<b>Docket Number:</b>	21-BSTD-01
<b>Project Title:</b>	2022 Energy Code Update Rulemaking
<b>TN #:</b>	238296
<b>Document Title:</b>	Statewide Utility Codes and Standards Enhancement Team Comments - on Indoor Lighting Beauty Salon
<b>Description:</b>	N/A
<b>Filer:</b>	System
<b>Organization:</b>	Statewide Utility Codes and Standards Enhancement Team
<b>Submitter Role:</b>	Public
<b>Submission Date:</b>	6/18/2021 4:33:30 PM
<b>Docketed Date:</b>	6/18/2021

## **Comments on Indoor Lighting Beauty Salon**

# Comment on Nonresidential Lighting for 45-Day Language

## 2. Update to Barber, Beauty Salon, Spa Area Category LPD

Figure 1: Small Beauty Salon

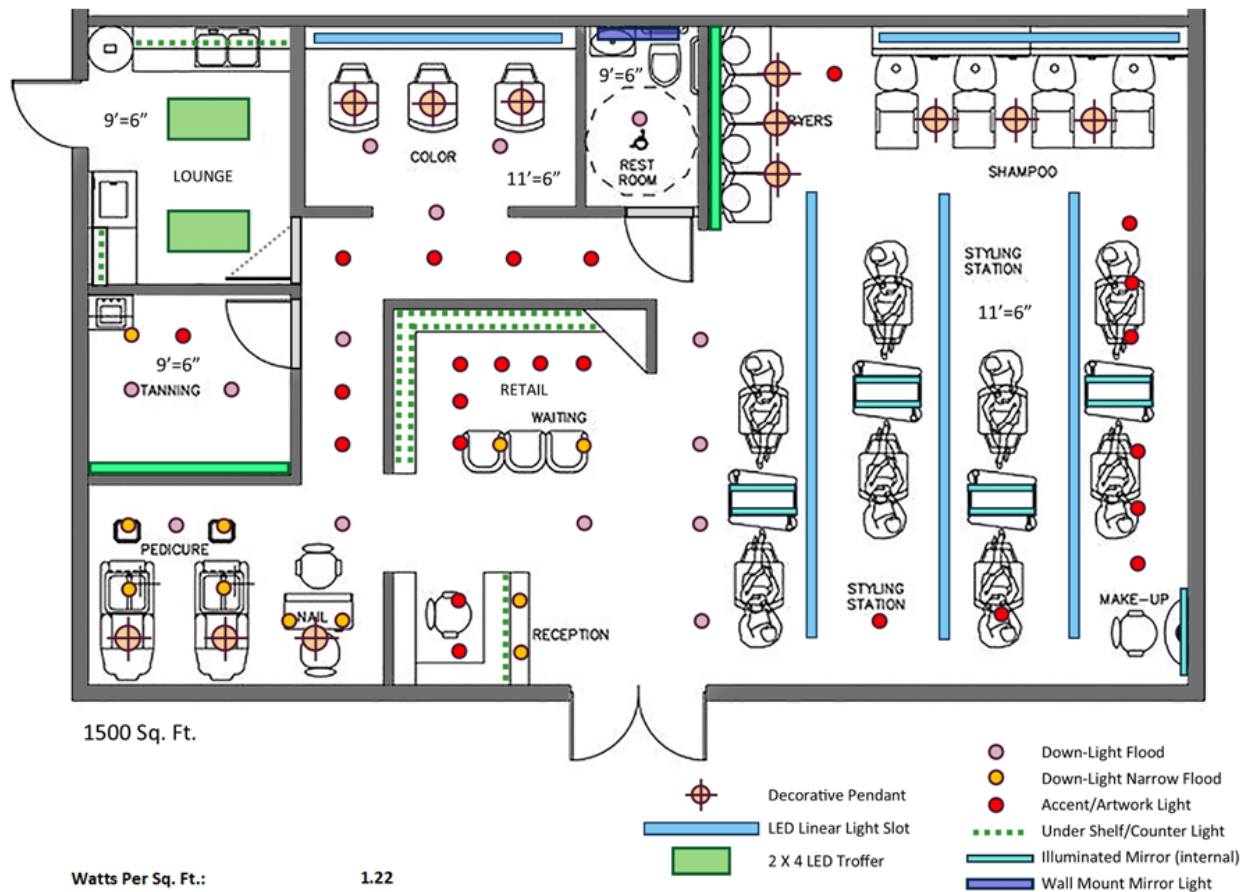
The Statewide CASE Team is recommending that general lighting LPD be increased from 0.65 W/ft<sup>2</sup> to 0.70 W/ft<sup>2</sup> and the detailed task allowance from 0.20 W/ft<sup>2</sup> to 0.30 W/ft<sup>2</sup> and display/decorative allowance remain the same at 0.25 W/ft<sup>2</sup> for a maximum allowable LPD of 1.25 W/ft<sup>2</sup>. The rationale is to allow “high end” designs for spas and the like where lighting is providing not only high light levels for beauty salon tasks, such as hair cutting and with high color rendering index for hair tinting, but also decorative and display lighting for illuminating artwork and with additional light sources, such as lights that are built into mirrors. A graphic of these designs is shown in Figure 1.

As the calculation in the graphic shows, this design, which has design features in demand by some of the beauty salons, cannot meet the 45-Day Express Terms total wattage target of 1.10 W/ft<sup>2</sup>. This design includes circulation lighting, task lighting above the various workstations, includes illuminated mirrors, display lighting or artwork, and task lighting for the financial transaction. There are many activities and different tasks occurring within a relatively small space. This design could barely comply if higher efficacy but lower quality light sources with a color fidelity of only 80 CRI were used. This would not be keeping with the intent of providing comparable amenity with less energy.

**CURRENT:** T24-2019 Area Compliance: 1.30 W Sq. Ft.  
**EXP. TERMS:** T24-2022 Area Compliance: 1.10 W Sq. Ft.  
**Proposed:** T24-2022 Area Compliance: 1.25 W Sq. Ft.

**Figure 2: Luxury Beauty Parlor/ Spa.**

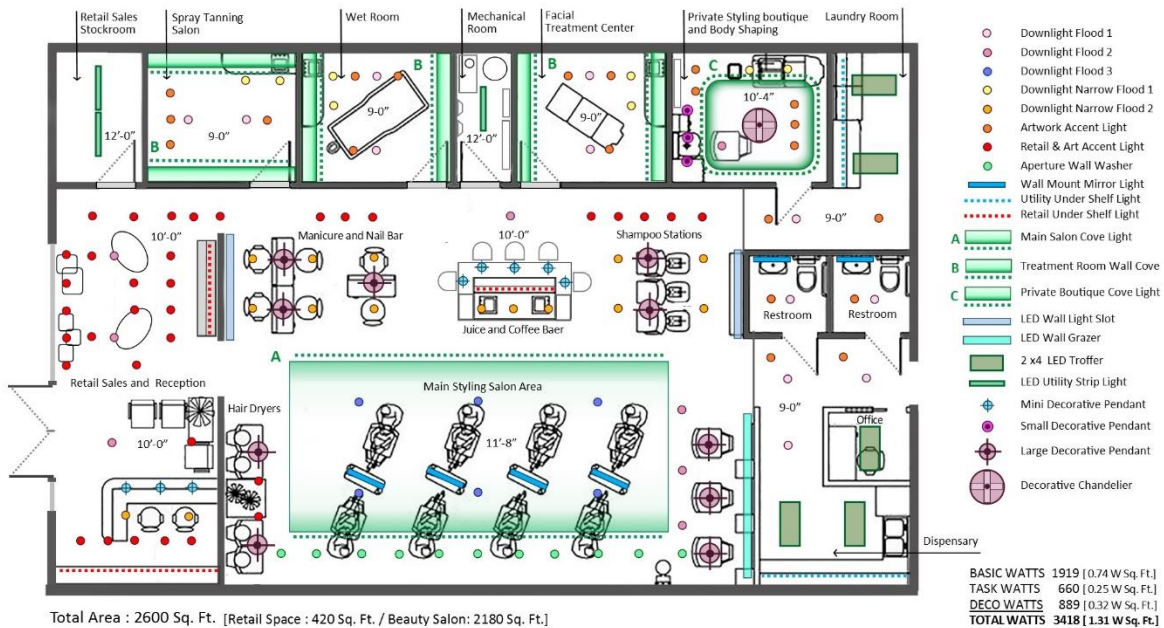
The revised lighting wattage allowance is proposed in lieu of having a Tailored Lighting Method approach for high end beauty salons. The sample designs developed here would accommodate most predicted needs for beauty salons. If even more lighting power was desired as shown in the luxury design in Figure 2 with lighting power density of 1.31 W/ft<sup>2</sup>, this could be accommodated by installing institutional tuning the lighting and making use of the 10 percent power adjustment factor and drop the adjusted lighting power to 1.18 W/ft<sup>2</sup>.
